SACKSAFOAM™ CONTROLLER

v01.00
02.28.2015

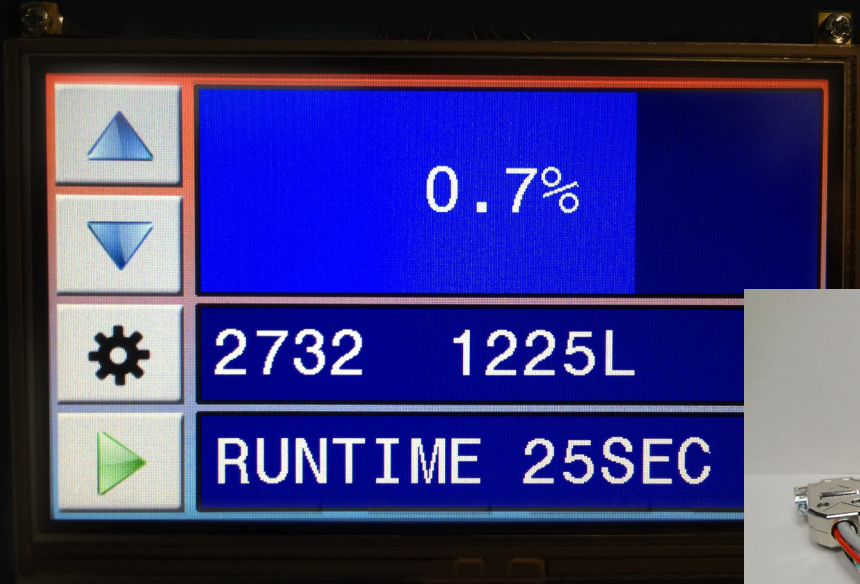
SEI is introducing a new Sacksafoam Controller (SFC). This SFC will supersede the original controller for customers with bladder style Sacksafoam I systems. Currently, the new SFC is not directly compatible with Sacksafoam II or Sacksafoam III systems. SEI will continue to provide the original controller to service Sacksafoam II's and Sacksafoam III's while stock exists.

The SFC is operated with a glove compatible touch screen. The SFC includes an adapter that connects to the existing Sacksafoam wiring harness and includes a D-sub connector that can be used to connect with a remote injection switch.

DZUS rail adapters are available for the SFC. Please note that the product dimensions have changed and the new SFC will not fit in the same location on a DZUS rail system as the original Sacksafoam controller.
